**ADDENDUM NO. 1
UNION STREET IMPROVEMENTS
CITY OF CONCORD, NORTH CAROLINA**

This Addendum No. 1 is issued this 20Th day of August 2020 to all parties who hold a set of Bidding Documents for the project entitled “Union Street Improvements, Concord, North Carolina”. This Addendum No. 1 shall become part of the Contract Documents and its receipt acknowledged on the Bidding Documents at the time of bidding.

SHEET
E-103

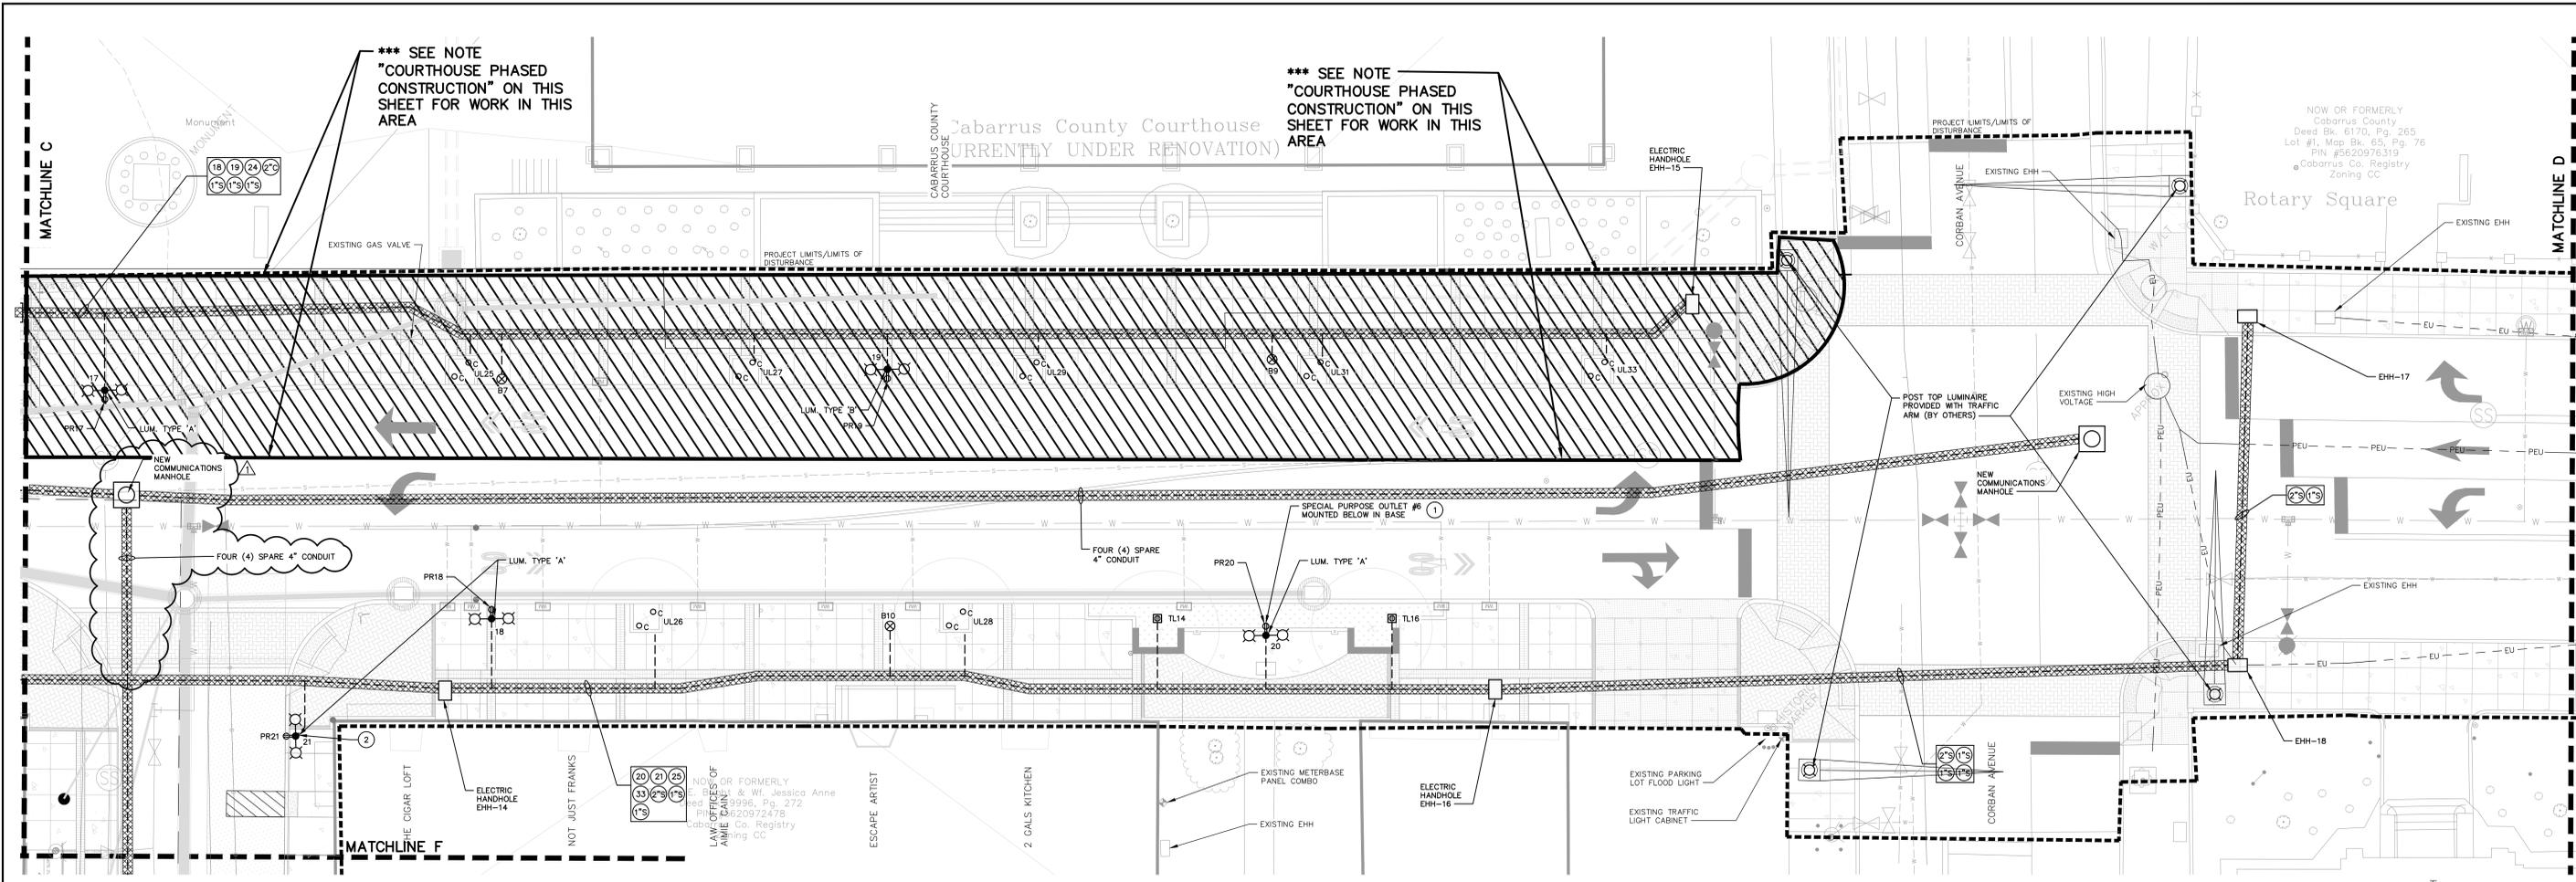
E-103 – Sheet number changed to A1_E-103. Manhole that was located on the right side of plaza has been moved to the next sheet.

SHEET
E-104

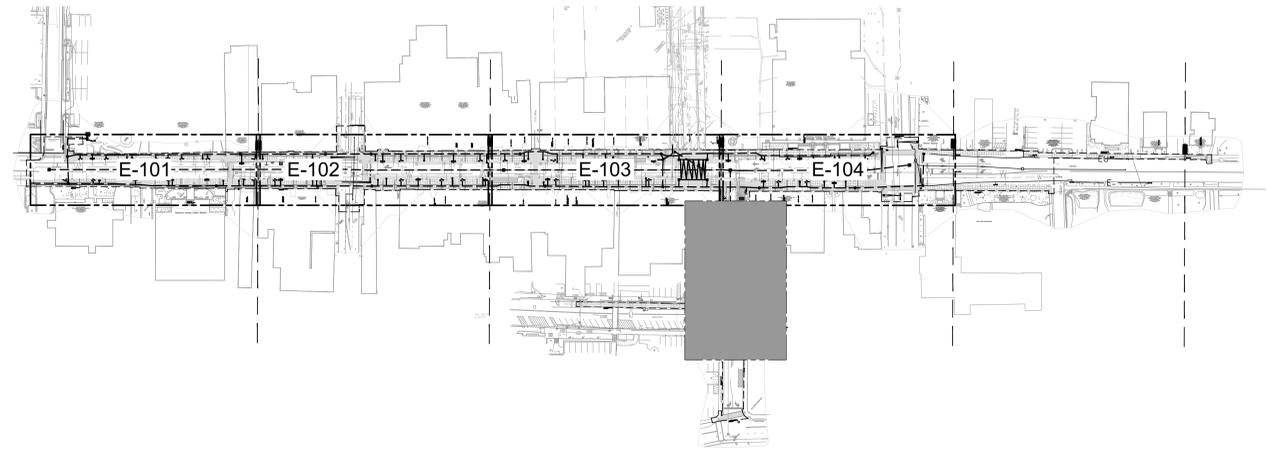
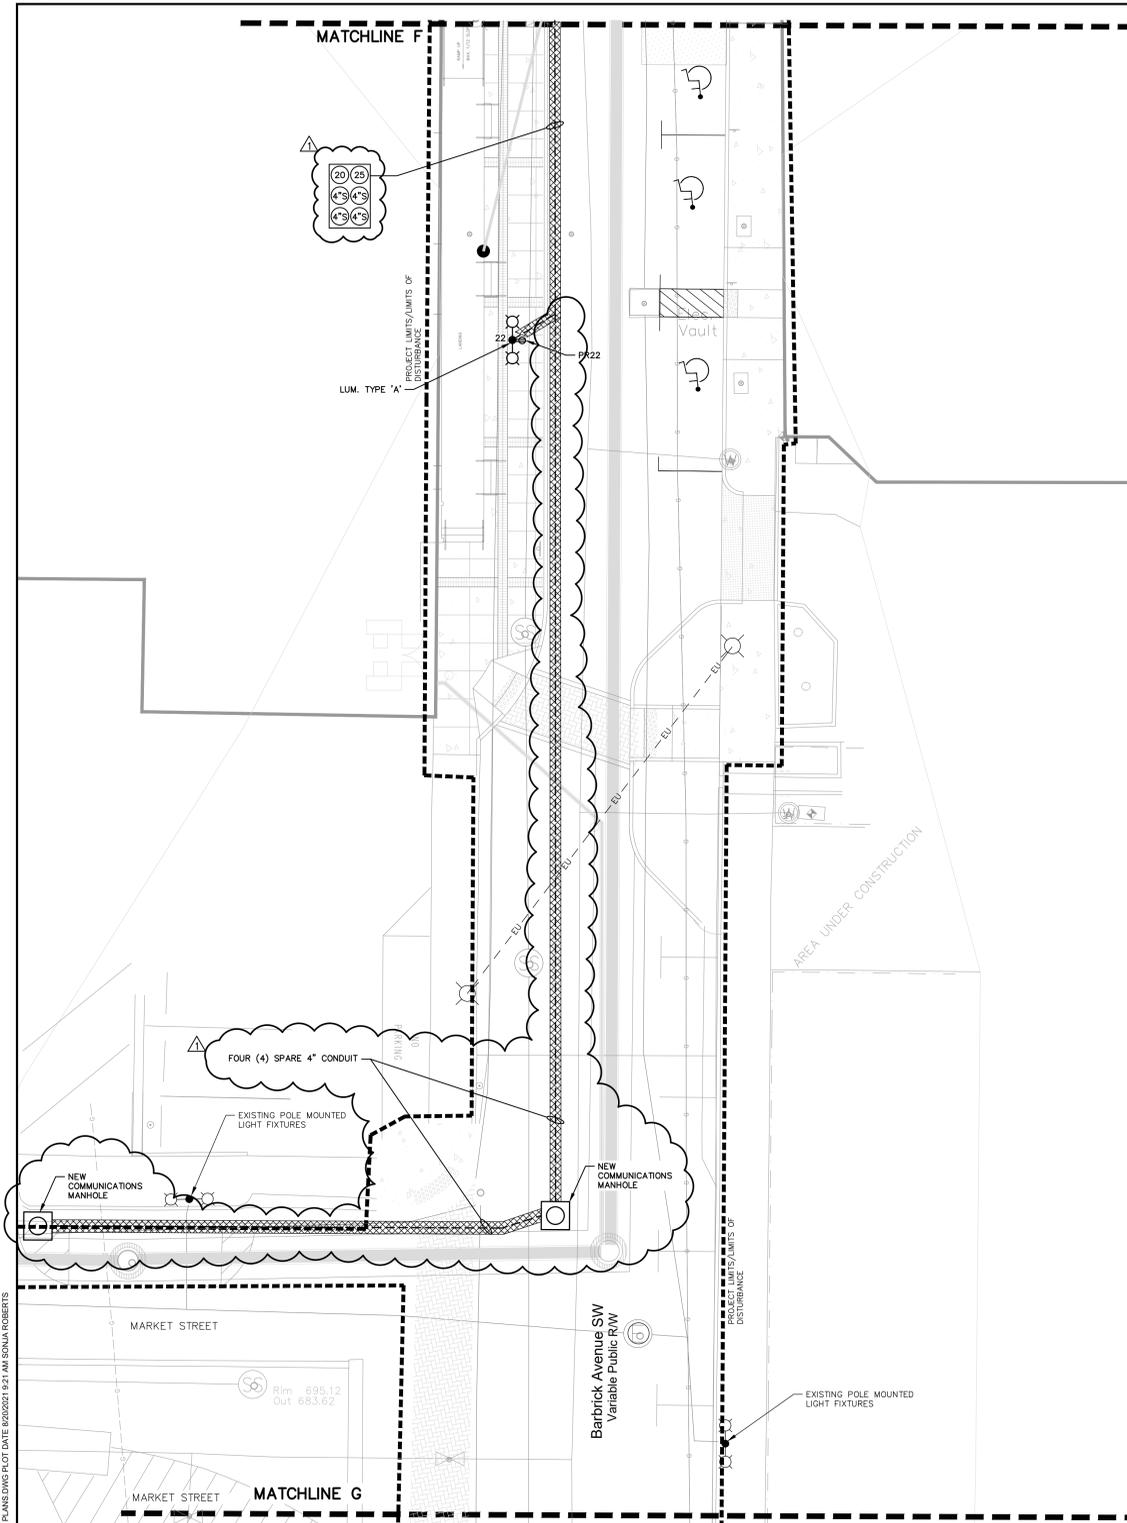
E-104 – Sheet number changed to A1_E-104. Manhole from previous sheet has been added to this sheet above Barbrick Avenue. Additional duct bank of four (4) spare 4" conduits has been added to run down Barbrick Avenue.
